CITY OF
West Linn

PLANNING COMMISSION MEETING

Memorandum

Date: October 5, 2012
To: West Linn Planning Commission
From: Zach Pelz, Associate Planner
Subject: CUP-12-02/DR-12-04; Amendment to April 18, 2012, Staff Report for the Planning Commission in response to the amended Water Treatment Plant application

Figure 1 Site plan revisions

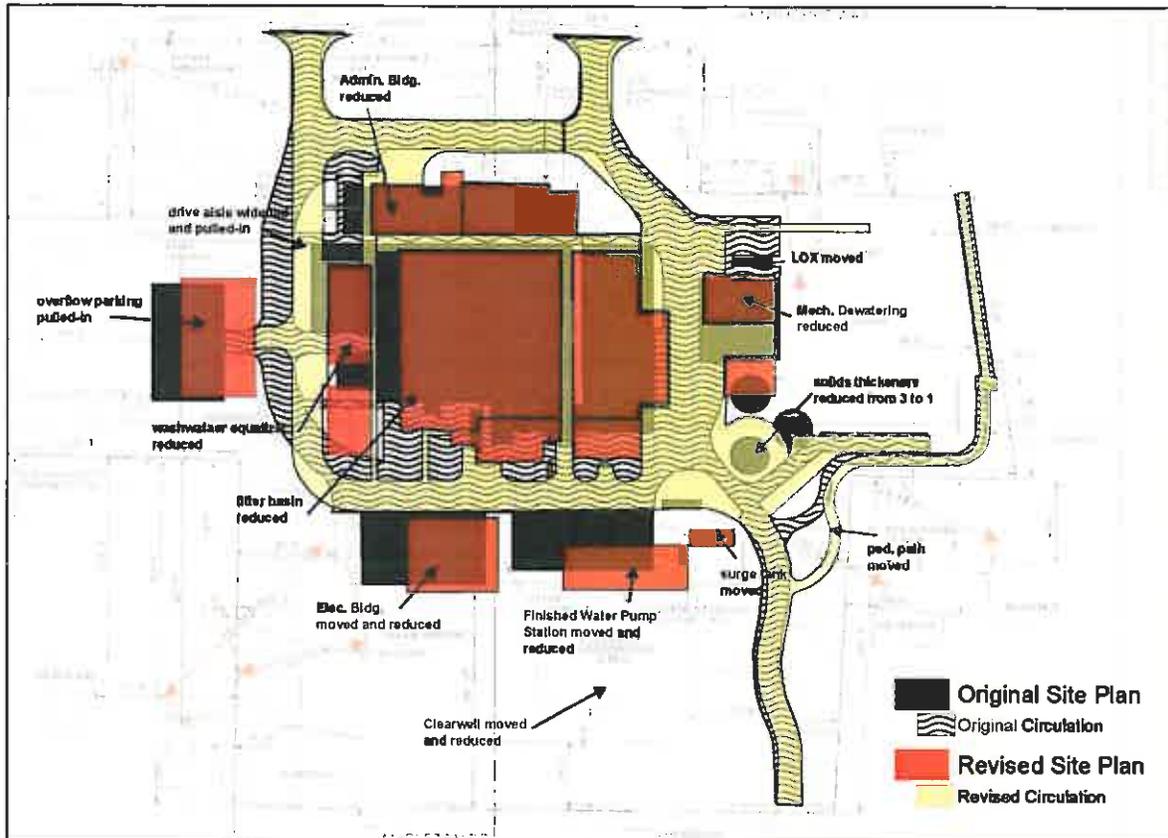
On August 20, 2012, the Partnership submitted revisions to their site plan and narrative for the proposed WTP expansion. According to the applicant, these revisions respond to concerns raised during the public hearings regarding CUP-12-02/DR-12-04 between April 18 and May 16, 2012, and include: reduction of water storage reservoir (clearwell) from 3 million gallons to 2 million gallons, reduction of the proposed building footprints by approximately 20 percent and increased separation between buildings, reconfigured drive aisles, relocation of the overflow parking area to increase setbacks from properties adjacent the site's western border, replacement of the three solids thickeners with one larger solids thickener, the addition of mature trees to provide greater screening between adjacent properties, the addition of a partially enclosed chemical delivery area to improve safety and reduce noise, the elimination of the carbon dioxide (CO₂) storage tank and compressor to reduce noise and relocation of the liquid oxygen (LOX) tank from the northeast corner of the site to the center of the site.

According to the applicant, these revisions result in less truck traffic during construction, less noise during construction, reduced visual impacts and an overall site disturbance reduction of more than 12,000 square feet from the original land use application. The complete list of revisions to the narrative, figures and supporting documents are outlined in Table 1, below and are shown in Figure 1, below:

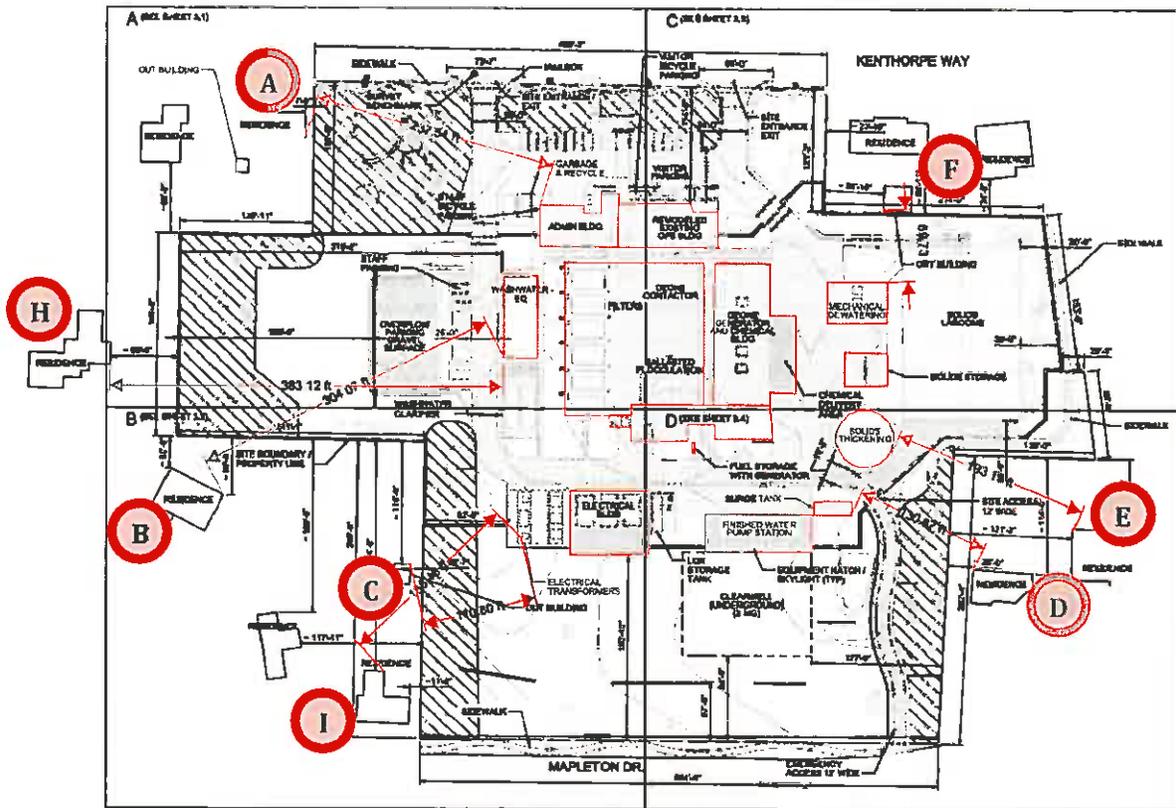
Revised Finding No. 23: According to the Applicant's proposed site plan, the minimum distance between any on-site and off-site building is approximately 70~~104~~-feet (distance between ~~liquid oxygen tank~~ mechanical dewatering building and adjacent ~~residences~~outbuilding at the northeast

corner of the site). The approximate distance between off-site and on-site buildings/structures is listed in the table below:

The separation of on- and off-site buildings provides ample distance for light and air circulation. Additionally, the applicant proposes a looped service driveway with emergency/fire access to all site facilities, and with emergency/fire access from both Kenthorpe Way and Mapleton Drive. The criterion is met.
